BULLETIN NO. 217

MACHINE: **Auto-Lift Serial Numbers 200 through 500**

SUBJECT: Axle Disconnect Kit

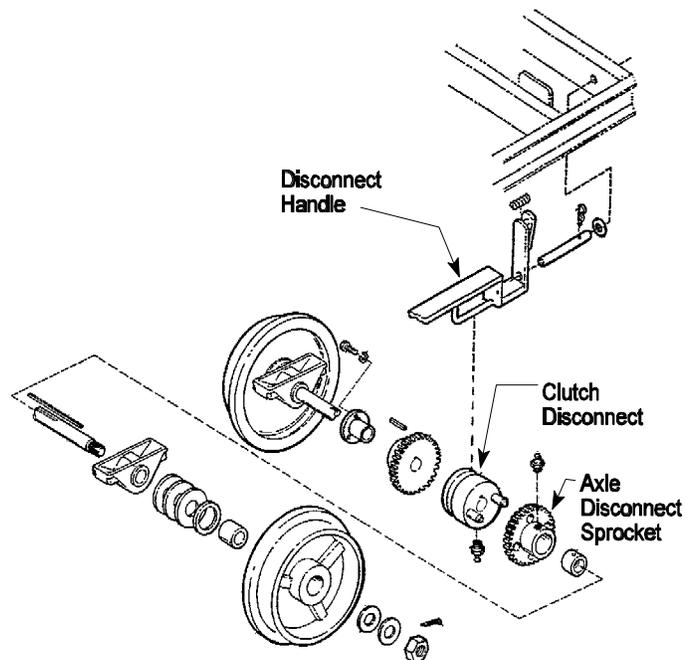
The Auto-Lift Axle Disconnect Kit, part number 9879 0097, provides a convenient way to disengage the drive axle for towing. This clutch replaces the pinned sprocket arrangement which was used on machines through s/n 500.

The kit consists of a new drive axle, clutch, clutch lever, sprocket, drive chain, hardware and installation instructions.

The axle assembly must be removed from the machine. The wheels are removed from the old axle and installed on the new axle. The clutch lever pivot plate must be welded to the frame and two holes cut in the frame for the pivot pin. Total installation time should be 6 to 8 hours.
